Subject:
Battle Street - Response to
Condition 30

The following information has been prepared to discharge Planning Condition 30 of Planning Application 22/1405 for the Land at Battle Street, Reading. The SuDS design and associated maintenance requirements follow the principles of the approved scheme which was granted permission 7th September 2023.

Comments from LLFA and Landscape Officer:

Drawing Title:
Roof Types

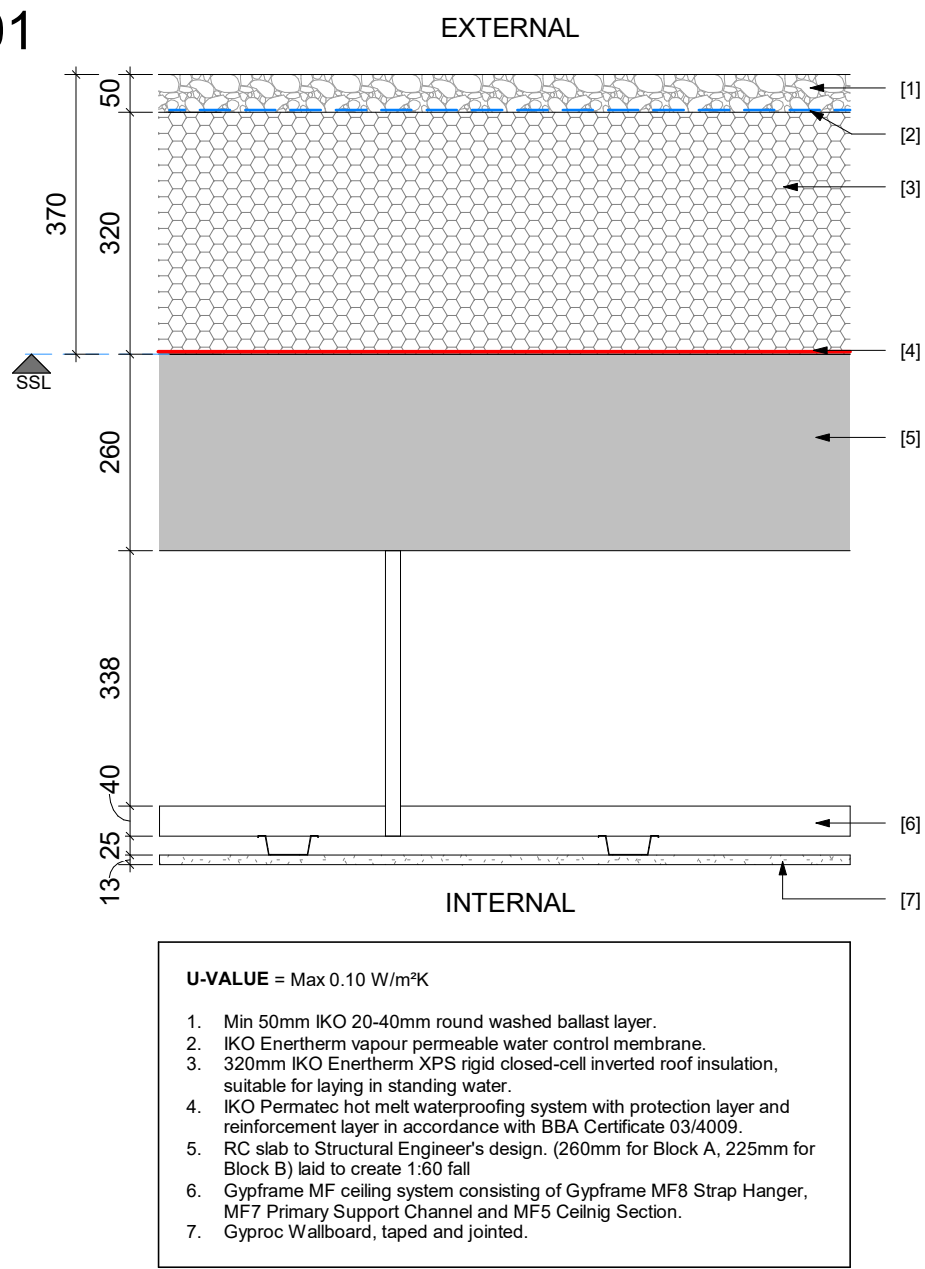
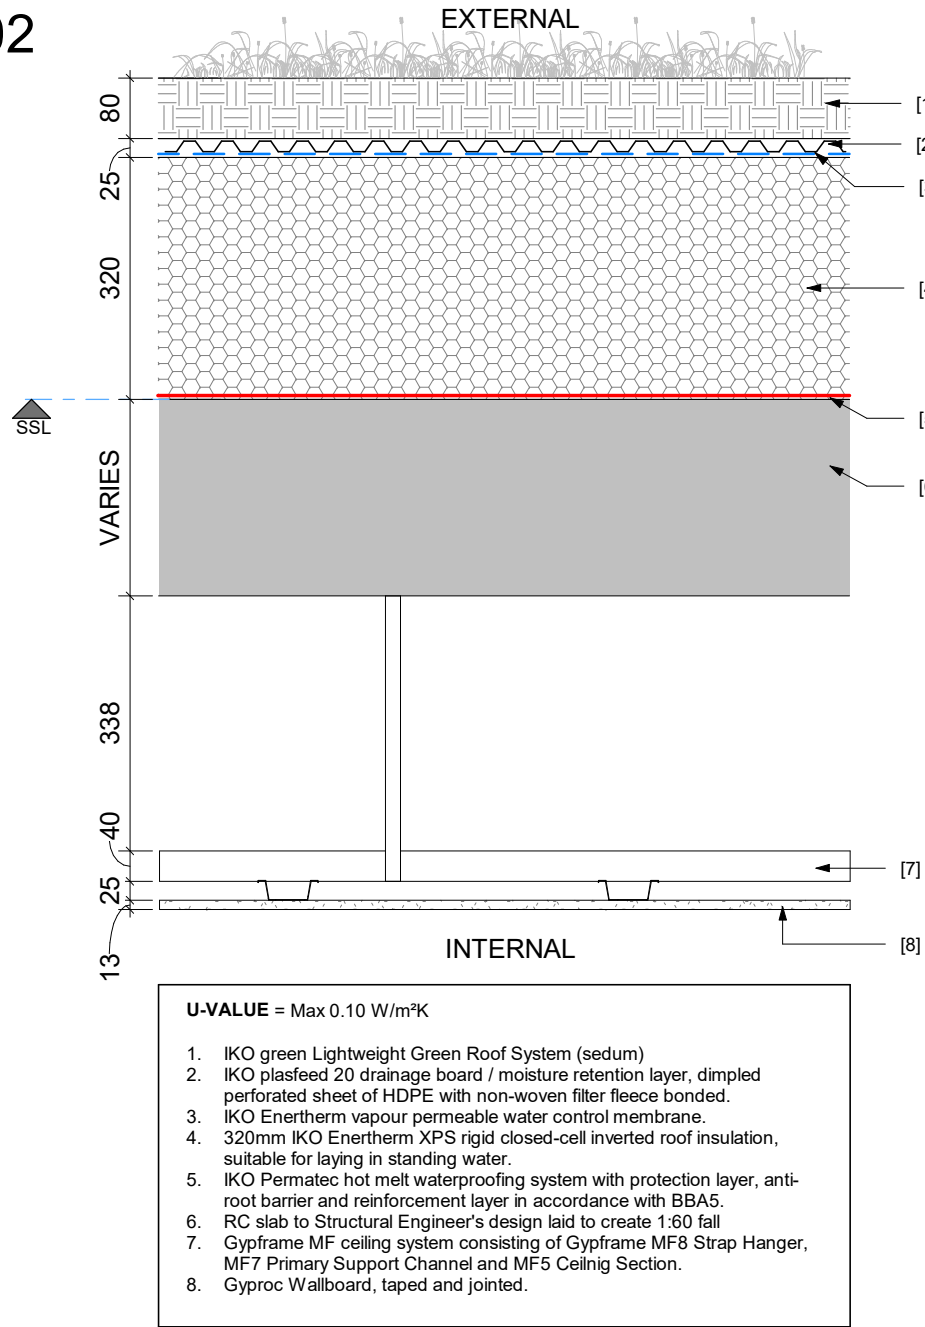
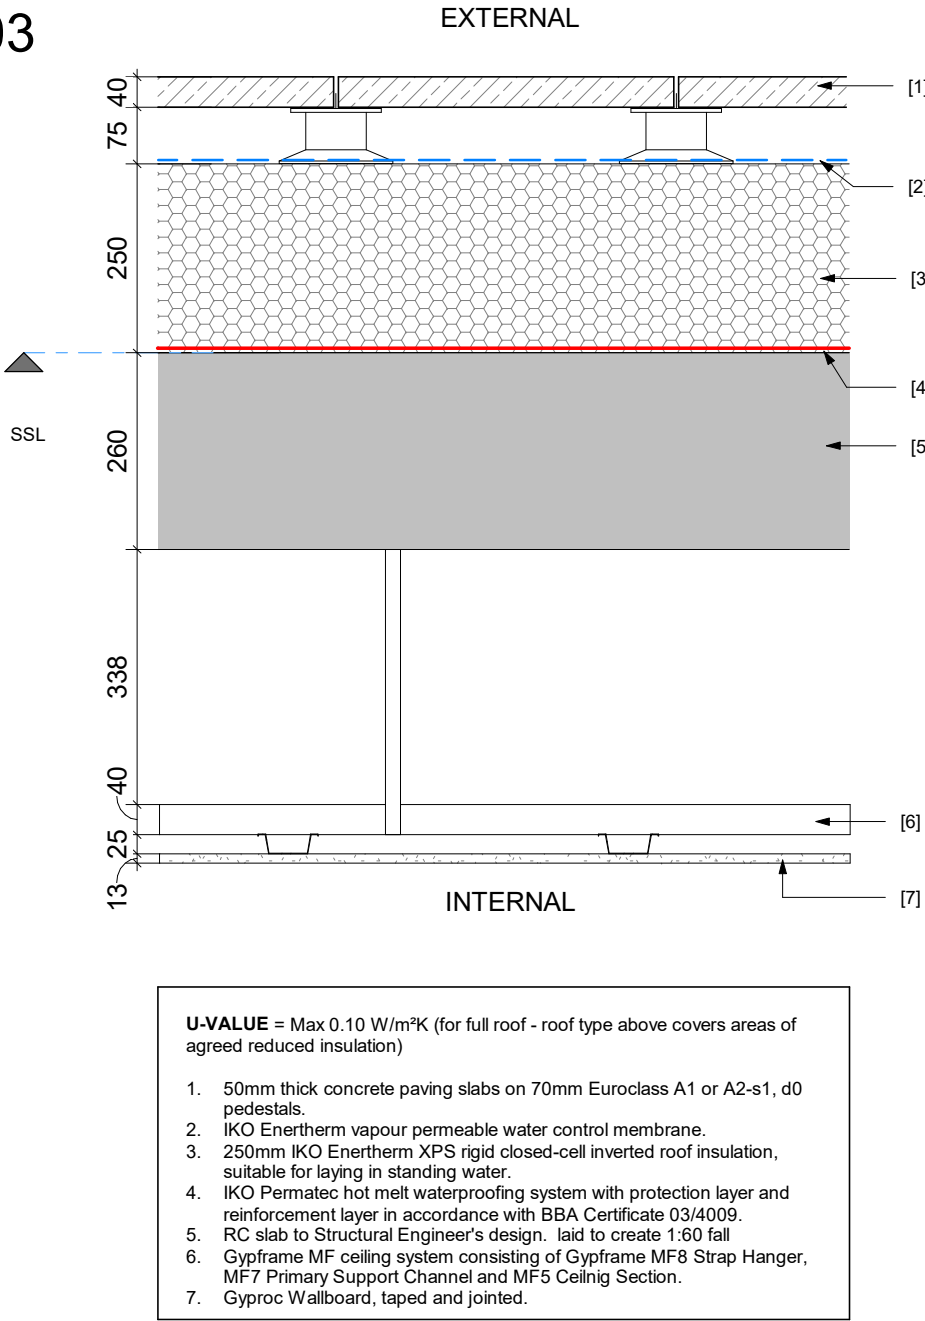
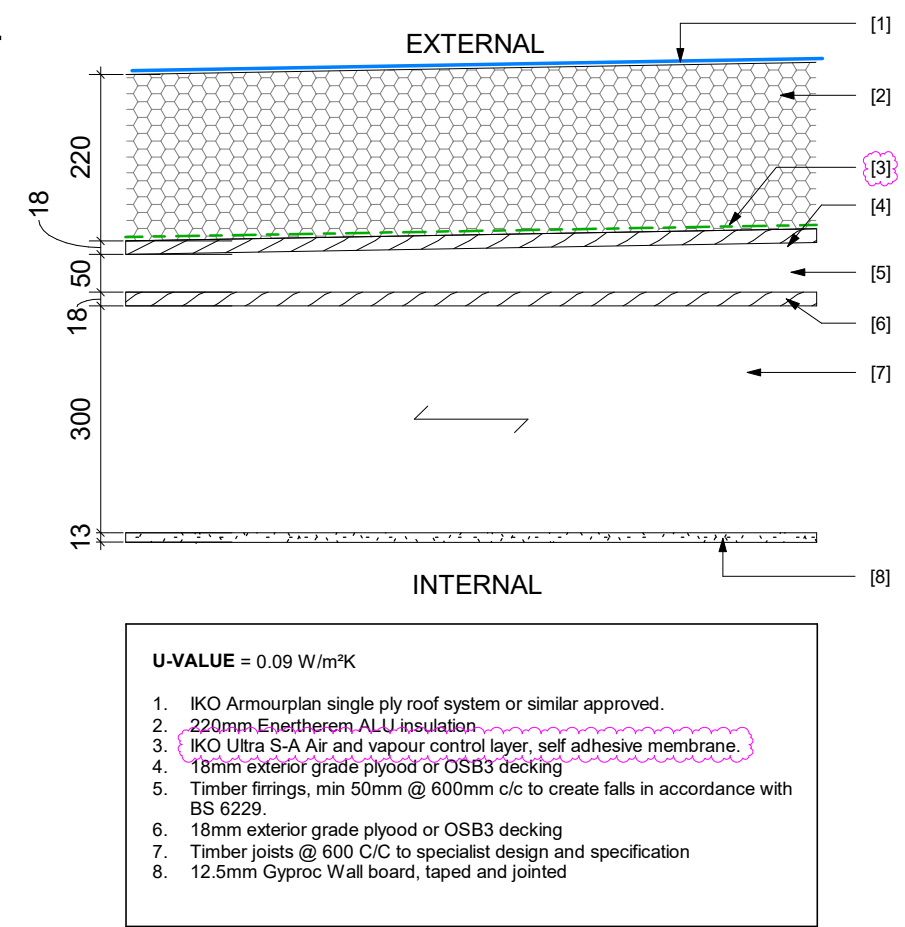
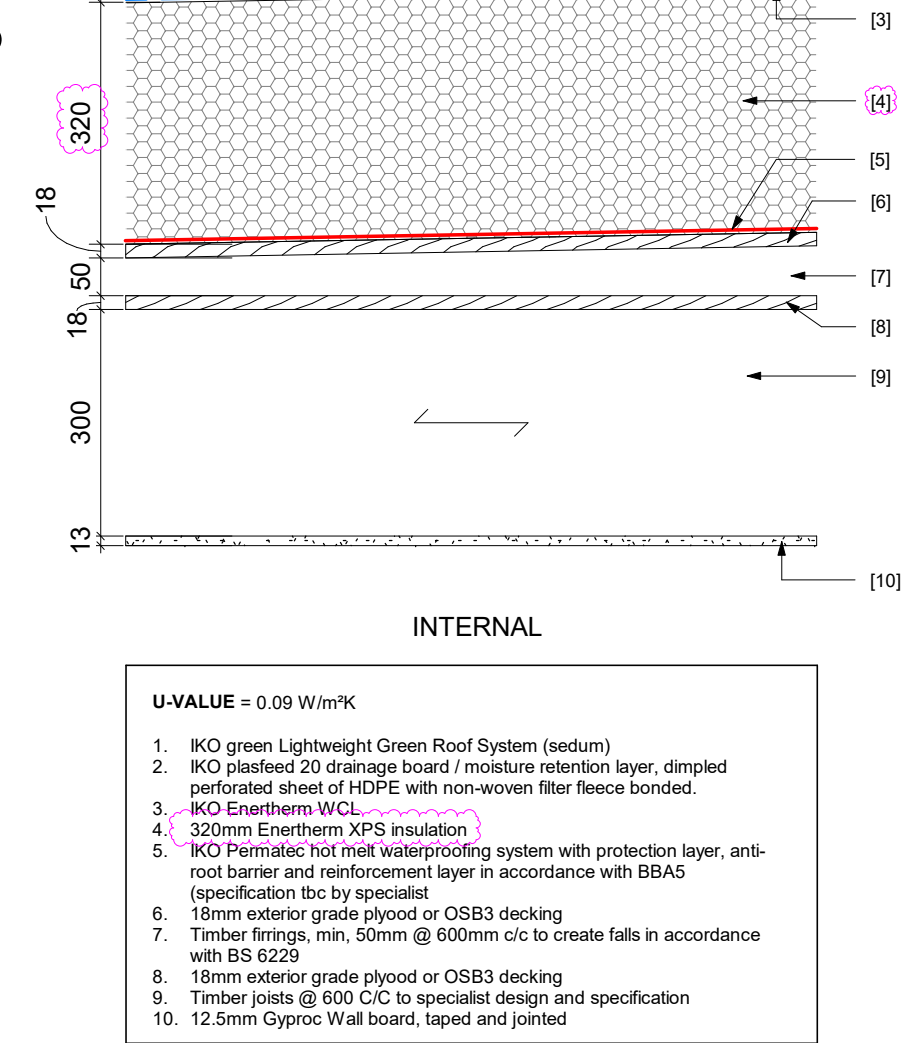
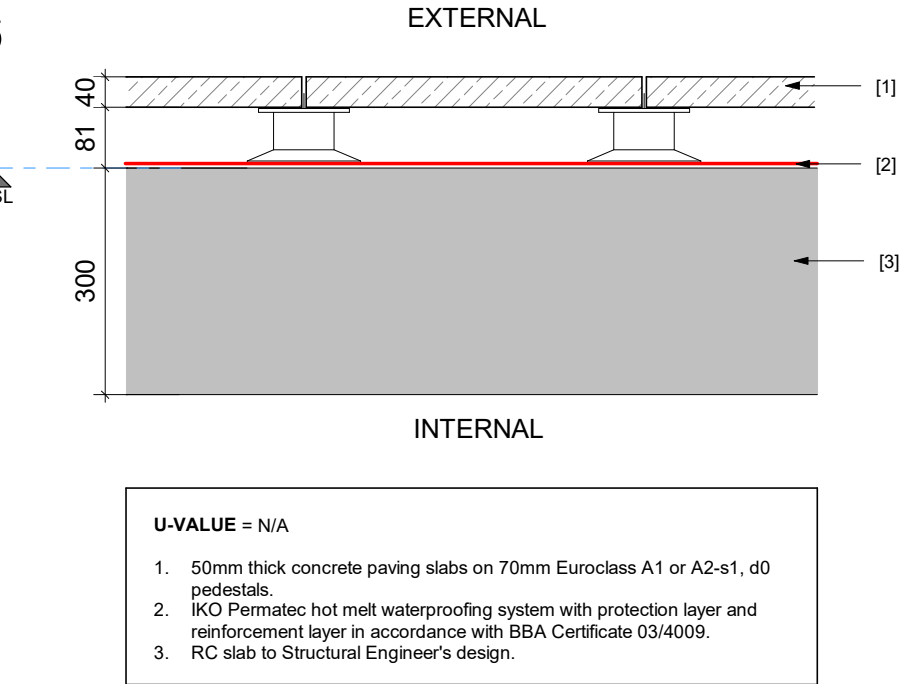
Comment 1: *a green roof has not been provided on any of the submitted drawings*

Response: a green roof is shown on drawings referenced below:

Block A – Main Roof to Ext. Wall Parapet Detail – BAT-BBA-XX-XX-DR-A-31110
Block C & E2 – Timber Roof Parapet Detail (Sedum) – BAT-BBA-XX-XX-DR-A-31403
Roof Types – BAT-BBA-XX-XX-DR-A-31003
